CHIT RESOLUTION REPORT FOR THE PASSIVE PLATE FDR

NSTXU_1-1-1-2-1_CRR_100

Passive Plates

NSTXU_1-1-1-2-1_CRR_CHIT_100

UR-VVHW-2032 - Line of sight from LiTER probe

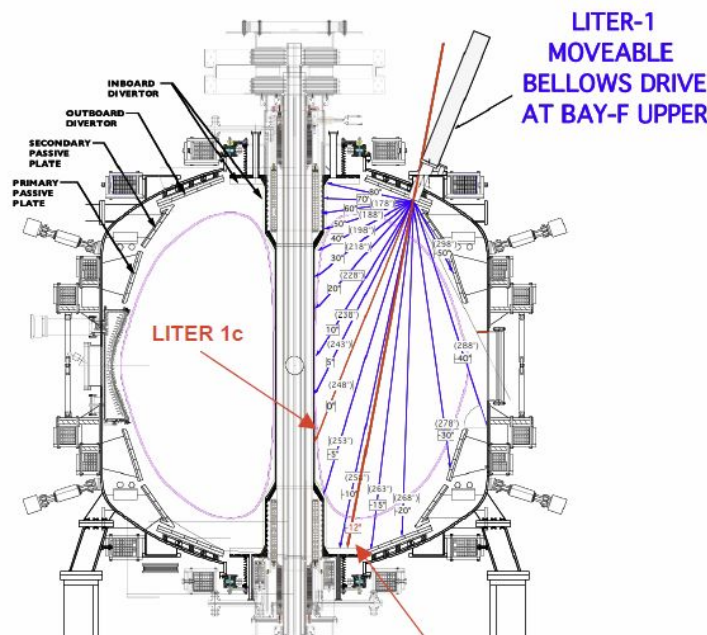
Review	ID	Chit
Passive Plate PDR	PASPLAPDR 11	Determine if there are any direct lines of sight from LiTERs to resistive connectors/jumpers. May not be acceptable to have lithium directly depositing on thin copper strap - this could be another reason to protect copper with a parallel stainless layer.

A The drawings and FDR presentation for the LiTER probes reviewed. Copper brackets are behind the Passive plates and close to vacuum vessel wall, away from the LiTER's direct line of sight. See image below.
